BOARD OF APPEALS, CITY & COUNTY OF SAN FRANCISCO

Appeal No. **26-053**

Appeal of Building Permit 202608176686, issued 8/21/2026

280-282 Roosevelt Way, Block 2607 Lot 36

EXHIBIT 10b:

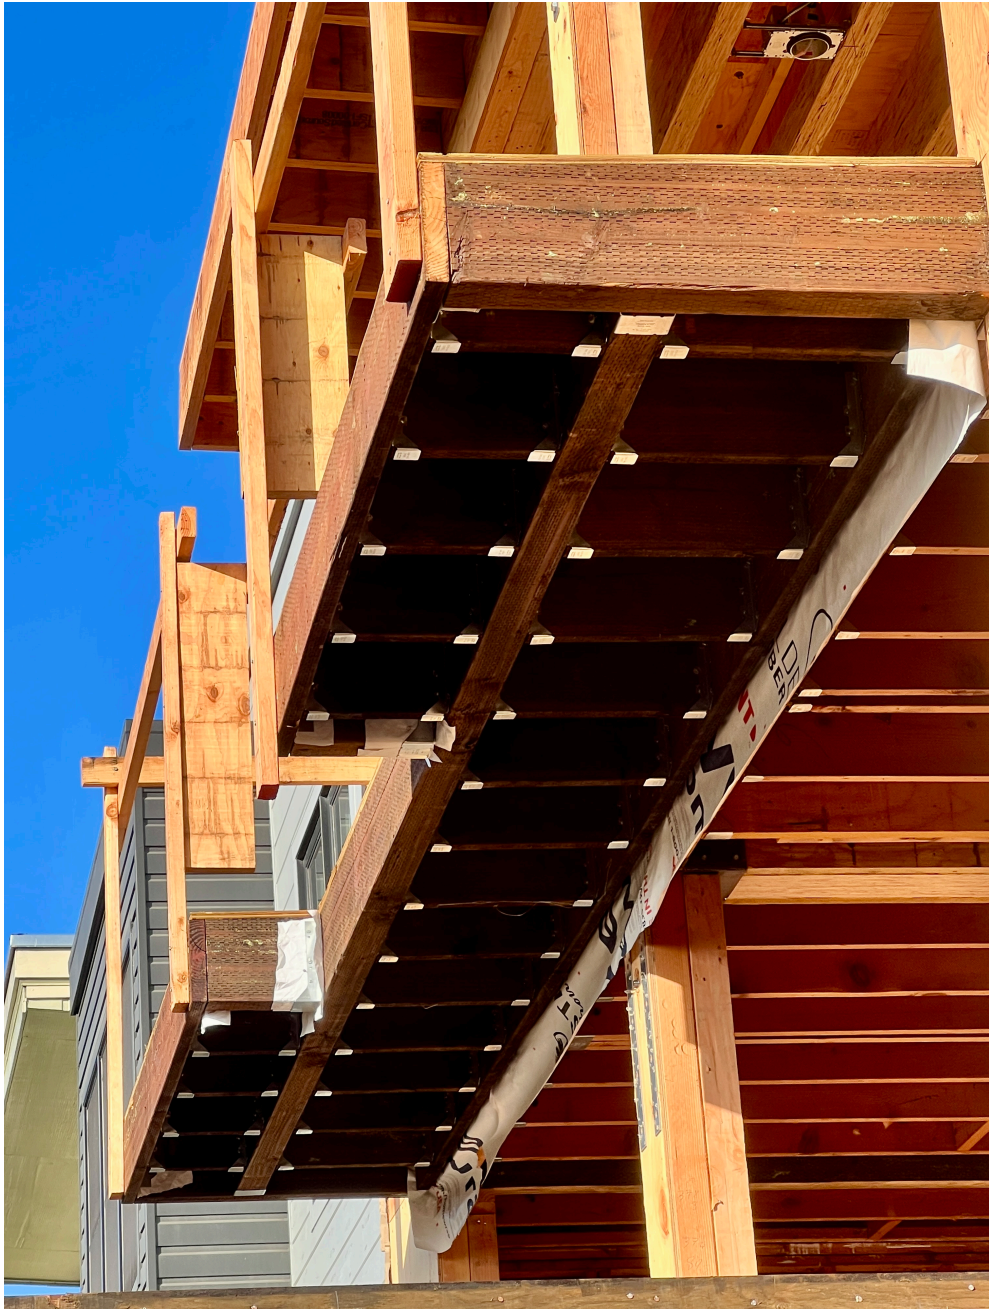
Without complete dimensions and notes, it is challenging to verify that these two bay balconies comply with the Planning Code. Reviewing the plans and looking at the constructed bay balconies, I have concluded that the northern of the two bay balconies was not measured from within the property lines of the subject **Lot 36**, but within the 21-inch encroachment on the adjacent **Lot 283**. Furthermore, the horizontal separation of the two balconies, in order to comply with Planning Code Section 136 (2) (G), would need to be increased from 5 feet to 7 feet. (I calculated 2, 2.5-foot sloped 45% angles = 5-feet + 2-foot horizontal separation at the FSB = 7-foot horizontal separation between the two proposed bay balconies.)

In addition, the plan indicates that the rectangular central section connecting the two bay balconies is located within the buildable area of the lot and does not project over the 10 foot FSB. I believe this dimension needs to be verified in the field.

The depth of the rectangular connecting section is not directly noted on the floor plan. It has to be mathematically calculated by subtracting the 2-foot 6-inch bay balcony projection over the FSB from the 3-foot 6-inch balcony dimension noted on the floor plan. The difference is 1 foot. This dimension differs from my measurement of the front building wall of 280-282 Roosevelt Way from my deck. It measured 11 feet 4 inches. With a 10-foot FSB the difference in depth would be 1 foot 4 inches within the buildable area. Which measurement is the correct depth of the rectangular central section

EXHIBIT 11:

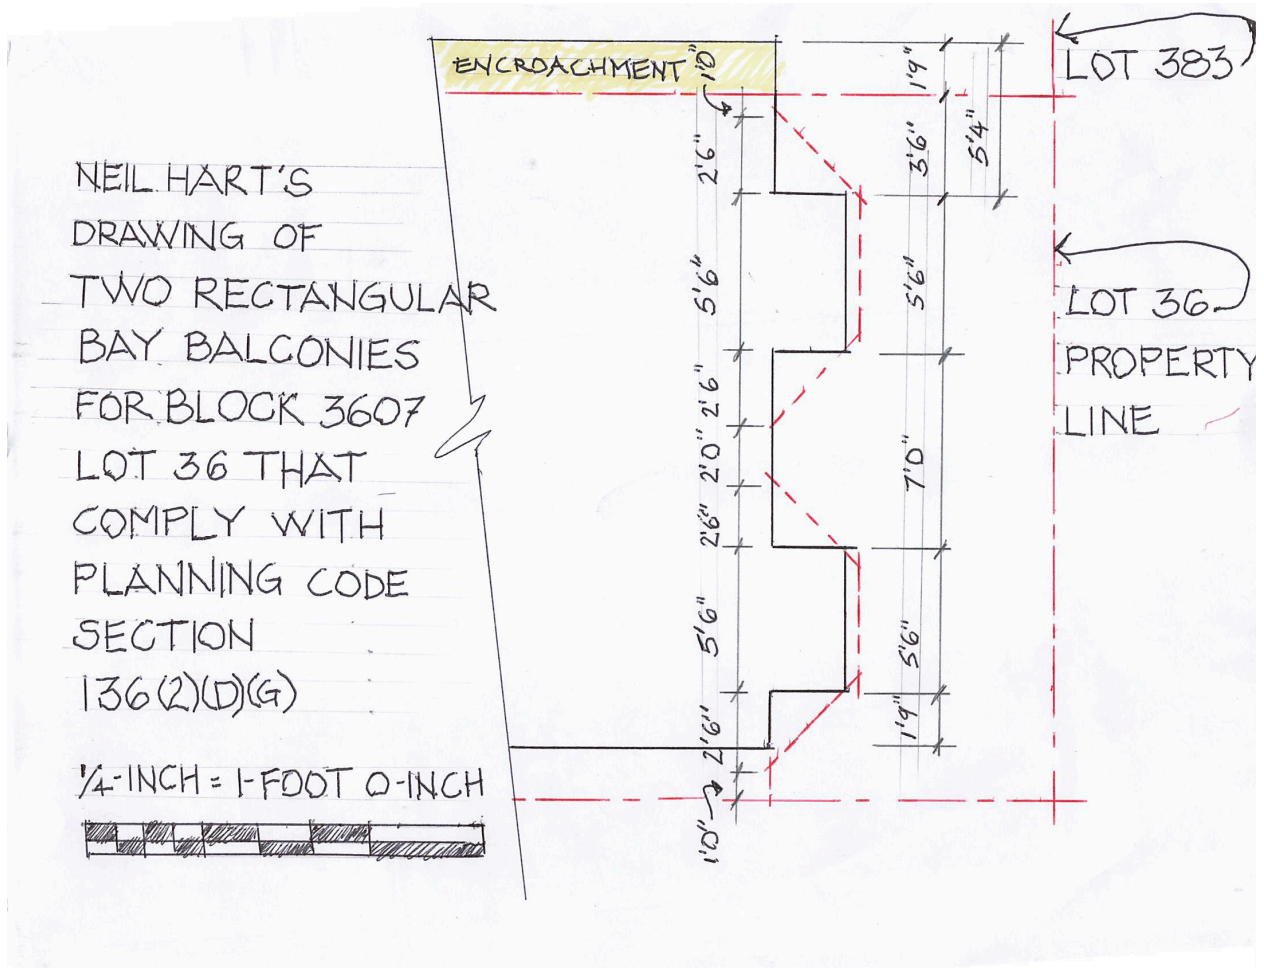
As the PDF plans I received from the Zoning Administrator in response to my Appeal have no graphic scale and are too small for me to accurately mark up, I have drawn **EXHIBIT 11** to illustrate what I believe the two rectangular bay balconies would look like if they complied with Planning Code Section 136 (2) (D) (G.) Each Bay would be shortened to 5-feet 6-inches from 6-feet 10 3/4-inches. The horizontal separation between the two bay balconies would increase from 5 feet to 7 feet, and the location the bay balconies would shift 21 inches to the south from the symmetrical center of the East (Front) Facade and be located 5 feet 4 inches south of Lot 36's property line.

Existing Balcony

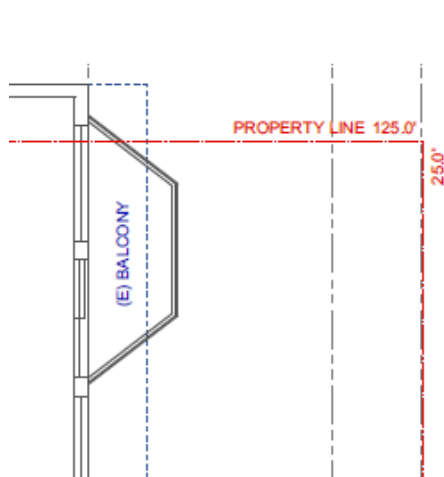
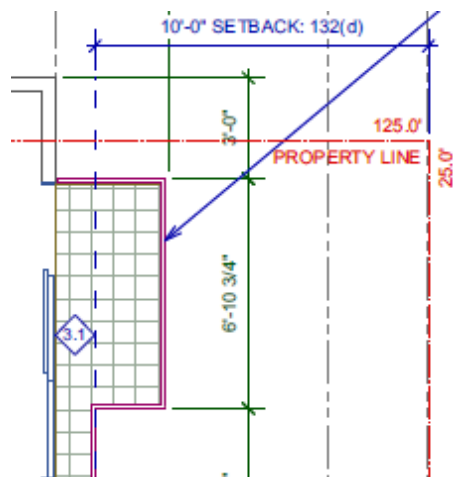
Third Floor Balcony Calculations: The exiting balconies have proposed modifications to both repair damage and comply with current code. The exiting balcony encroached 11" over the property line as it was based on the virtual property line when constructed. The proposed balconies have been reduced and set back 15" on to the legal property, and 36" from the building edge and visual property line. The complainant feels the side setback calculations should start from the physical property line, and not the existing building edge and virtual property line as per the existing conditions. From a Planning

point of view, to follow the offset physical property lines would have the block face with off center bay windows and balconies; it would look very odd, and not comply with the intent of the code. Planning code clearly illustrates setbacks as measured from the edge of the building. As the proposed balcony is not over the physical property line and is reduced from the existing condition there is no benefit or justification in increasing the side setback. A second issue is the front 10' Maximum Front setback. The balcony is allowed beyond the 10' front setback per Planning 1321(d) and has not been approval in error.

As the third-floor balcony and roof projection are reduced from the existing, and further reductions will adversely affect the façade of our building, we do not believe they are justified, especially as they have no real impact on the neighboring property.

1 THIRD FLOOR PLAN - PROPOSED
A2.3 Scale: 1/4" = 1'-0"

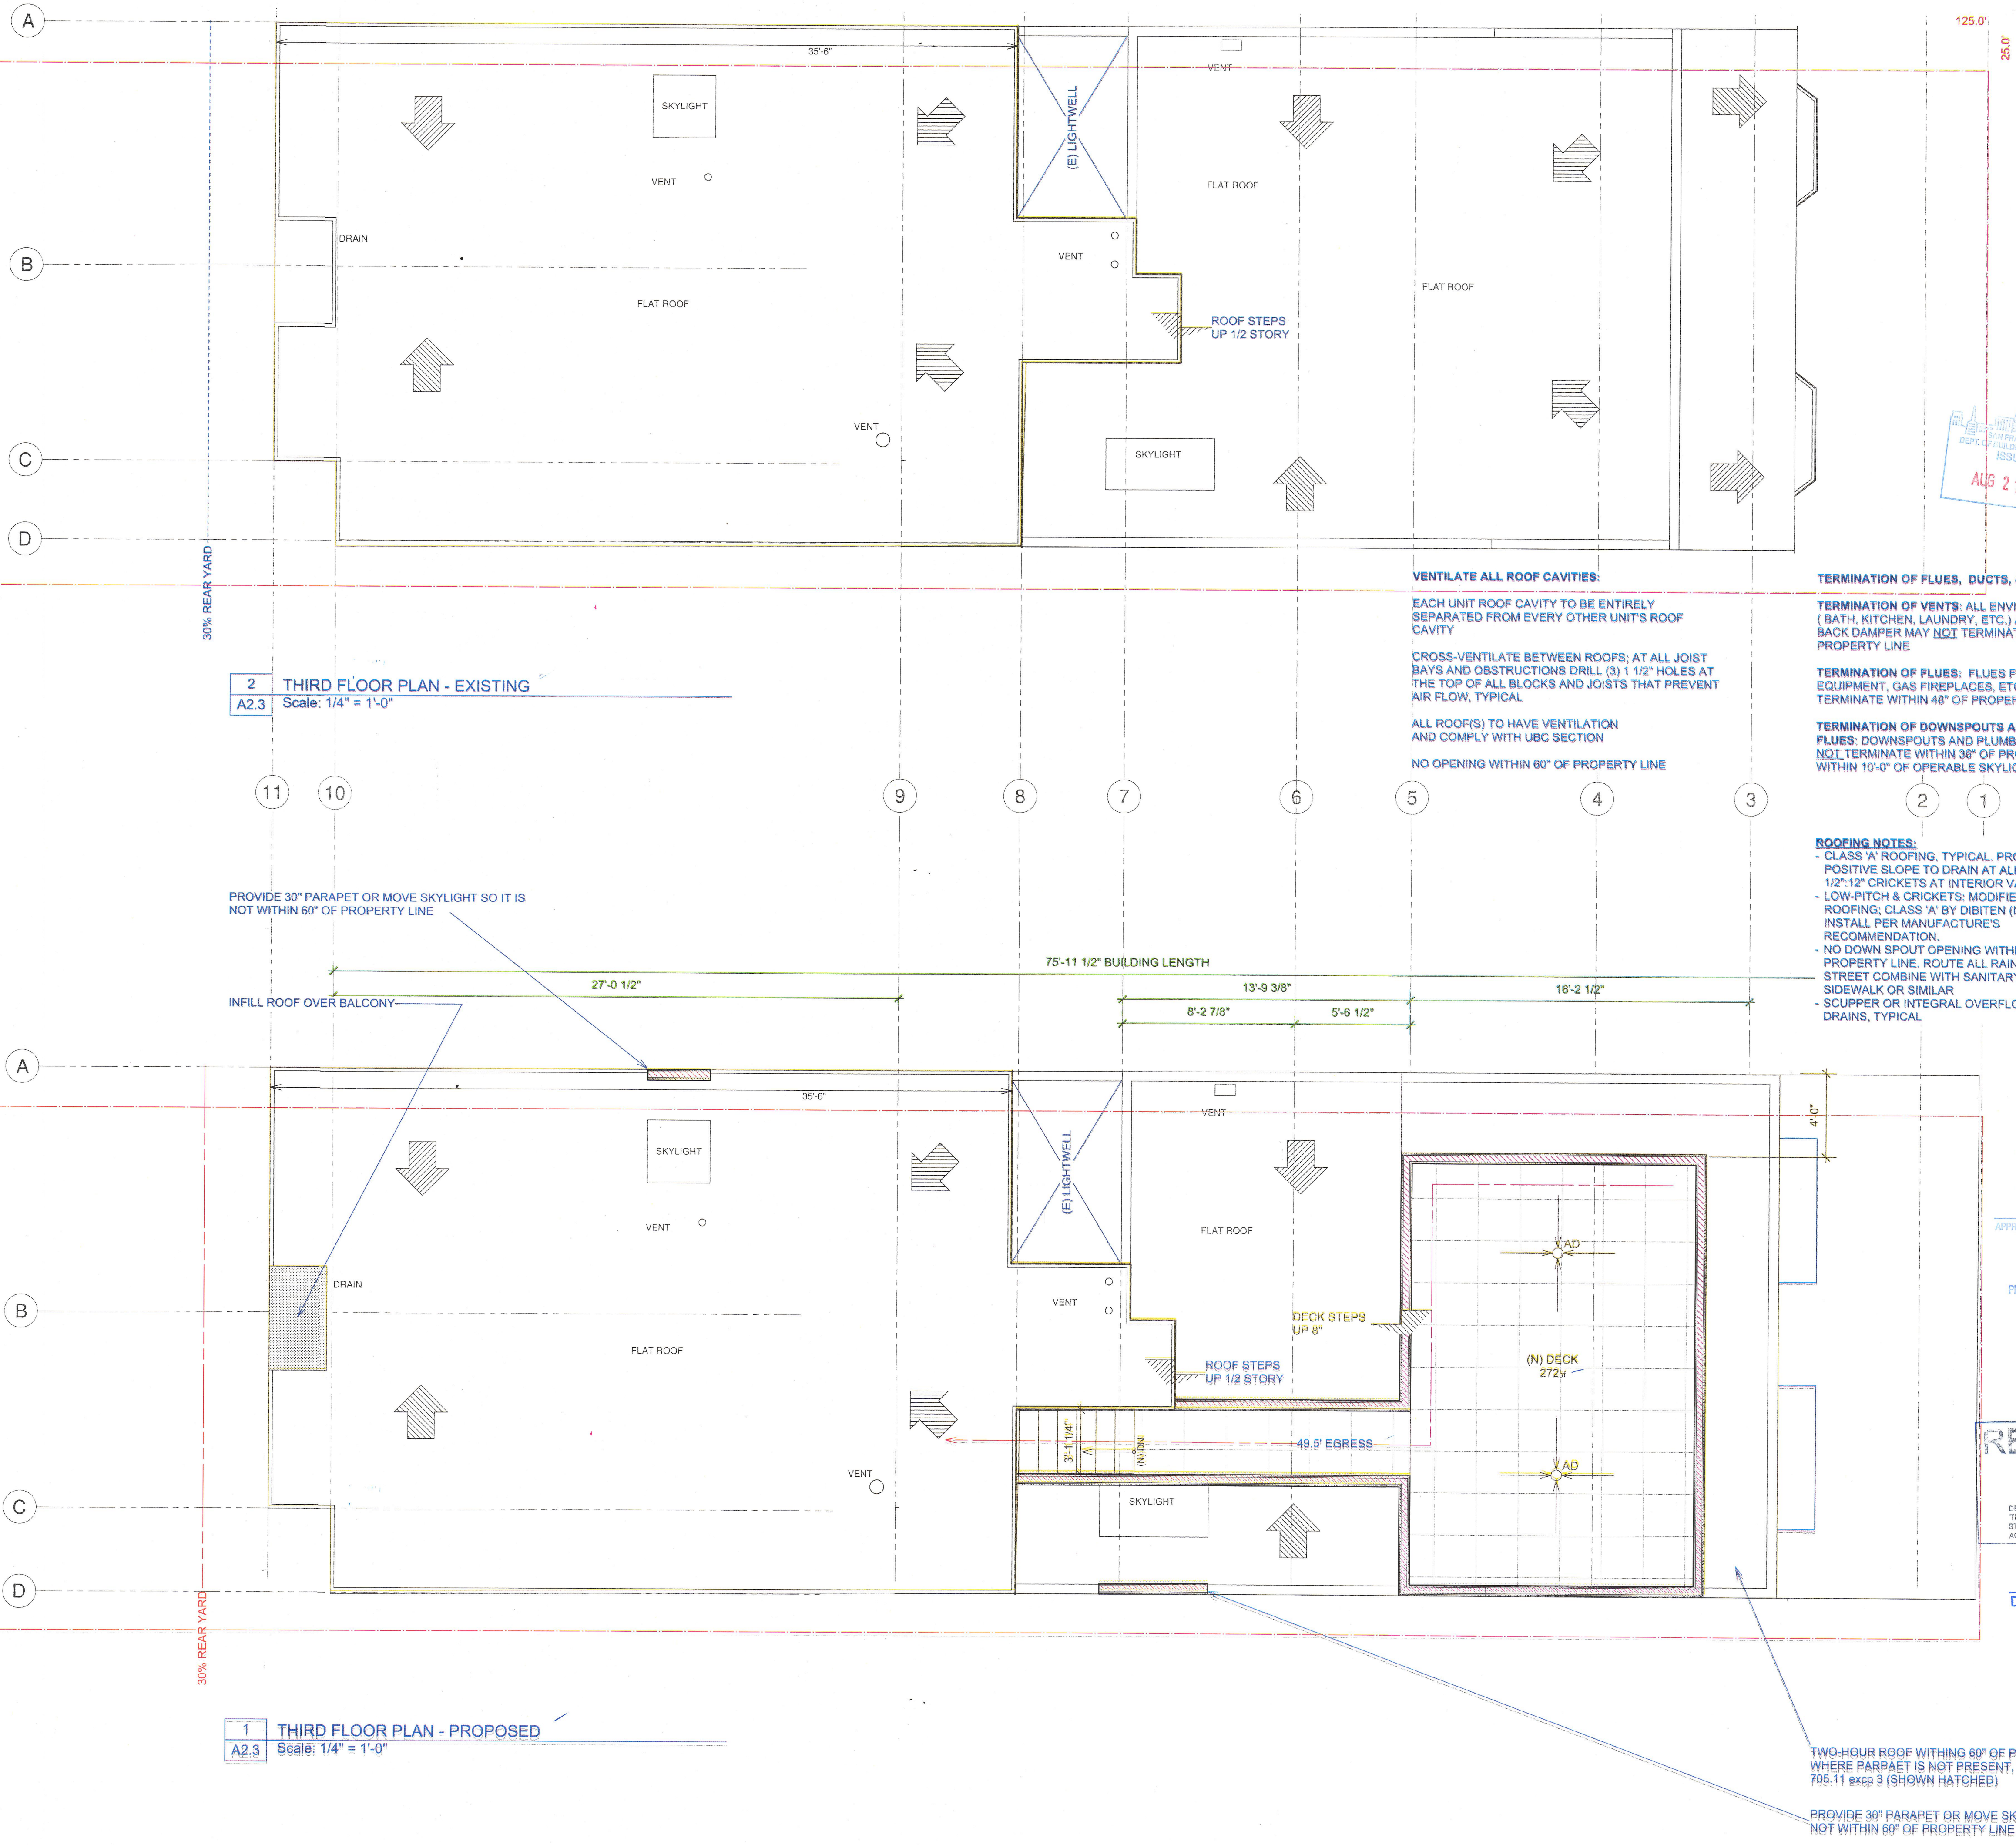
I have reviewed Sheet A2.3 Detail 1/A2.3 Third Floor Plan - Proposed in depth. Planning Code Section 136 136 (2) (D) provides a diagram and describes the dimension for a bay balcony projecting over the Front Setback. The diagram is in the shape of a trapezoid with 45-degree sloped, angled side walls. When the Project Sponsor proposes a rectangular bay balcony, it needs to fit within the geometry of the 45 degree sloped angle.

On Sheet A2.3, detail 1/A2.3 Third Floor Plan - Proposed, the Project Sponsor and Architect provide a red dashed line indicating the trapezoidal bay described in Planning Code Section 136 (2) (D) within which the southern balcony of their two proposed rectangular bay balconies is located.

The drawing fails to provide a red dashed outline for a second trapezoidal bay within which their northern rectangular bay balcony is located. Furthermore, there is no

Regarding the proposed front balcony, the Appellant is correct that Planning Code Section 136(c)(2) requires such balconies within the required front setback to be set back 1 foot from the side

property line, and then extend at a 45-degree angle, plus other limits for depth, width, etc. (see diagrams below from Planning Code Section 136(c)(2)). The proposed balcony meets the 1-foot side setback but does not meet the 45-degree angle requirement.

While the front balcony in the Permit is not fully Planning Code compliant on the north side, Planning Code Section 307(h)(1)(F) allows the Zoning Administrator to grant an administrative modification for bay windows or balconies “that maintain the same massing as those allowed as a

permitted obstruction in Planning Code Section 136, but do not otherwise meet the requirements of Section 136.with the advice of the Planning Director that said windows otherwise meet all applicable design guidelines.” The proposed balcony in the Permit was reviewed by the Zoning Administrator and Planning Department design staff and determined to be eligible for this modification and consistent with applicable design guidelines.
